Technical Bulletin

K015571XS/K015572XS for Ford Transit 2.5 D

GATES REFERENCE :	K015571XS / K015572XS
MAKE :	FORD
MODEL :	Tourneo, Transit
MOTOR :	2.5 D / TD
MOTOR CODE :	4BC, 4CC, 4DA, 4EA, 4EB, 4EC, 4FA, 4FD, 4GA, 4GC, 4GD, 4HA, S1

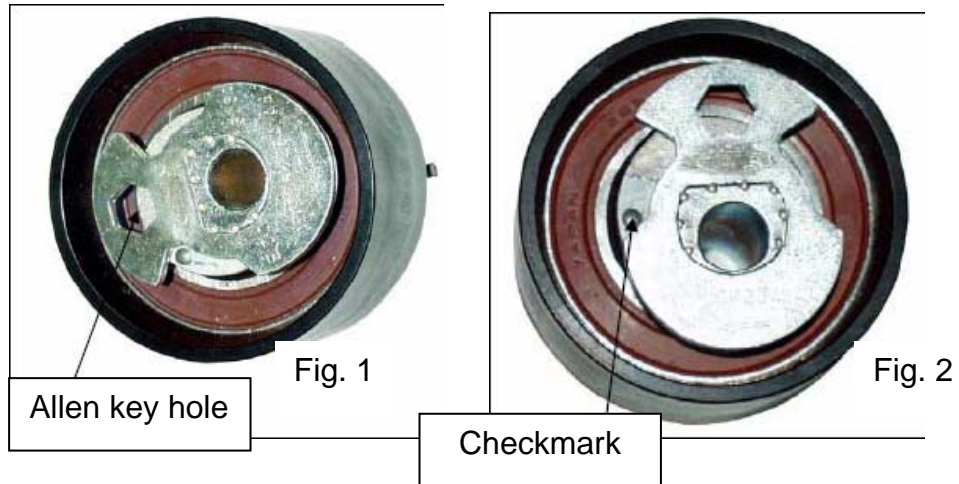
These kits contain an automatic tensioner and its specific bolt, which can be installed as replacement of a manual or an automatic tensioner. Although some sources still list the manual tensioner for the Turbo Diesel version, the Ford workshop installs the new kits (with automatic tensioner) on both Diesel and Turbo Diesel engines.

The automatic tensioner can be mounted in place of the old (manual) tensioner, without any modifications or special tools. Since some mechanics were unclear with the exact installation, we would like to explain the correct procedure. Please see attached.

- 1 Bring engine to TDC (Top Dead Centre)
- 2 Block flywheel (13 mm pin), camshaft and injection pump
- 3 Slacken bolts of injection pump pulley
- 4 Remove belt and tensioner
- 5 Install new (automatic) tensioner with new bolt hand tight (Allen key hole at +/- 9.00 o'clock) (Fig. 1). Install new belt.
- 6 Turn tensioner clockwise (with Allen key) until the checkmark is positioned just above lower edge of cut-out part (Fig 2).

7 Lock tensioner bolt (40-45 Nm)

10 Rotate engine 2 revolutions, check if tensioner mark is still just above lower edge of cut-out part (Fig 2). If not OK, restart procedure.
